UNITED STATES PATENT AND TRADEMARK OFFICE

APPLICATION NO.	FILING DATE	FIRST NAMED INVENTOR	ATTORNEY DOCKET NO.	CONFIRMATION NO.
10/696,463	10/30/2003	Ming-Tien Lin	HANP0022USA	6011

Office Action Summary

DETAILED ACTION

FIG. 3E

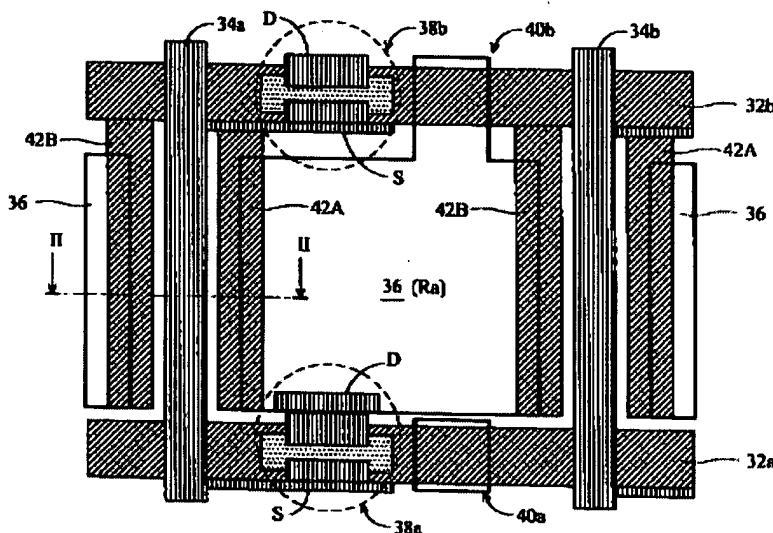
Claim 31 is objected to because of the following informalities:

Newly added limitations as to "... overlaps across the switching element" is considered incorrect [not the disclosed invention]. Please reference Applicant's Figure

3E of the elected invention. 42A overlaps the extension portion of data line 34a that runs from 34a to the source of the TFT, 38b, at S [see instant Specification, page 6 (pages not numbered), lines 8-10].

Please note that extending light shield 22a of APA to connect to gate line 12a would result in overlap with the extending portion of 14a [applicant's claim 31].

as per the teachings of Okada [this would result in overlapping the extension portion of the data line near the switching element or TFT as in Figure 3E].

For examination purposes, examiner will consider overlap per elected embodiment as shown in Figure 3E.
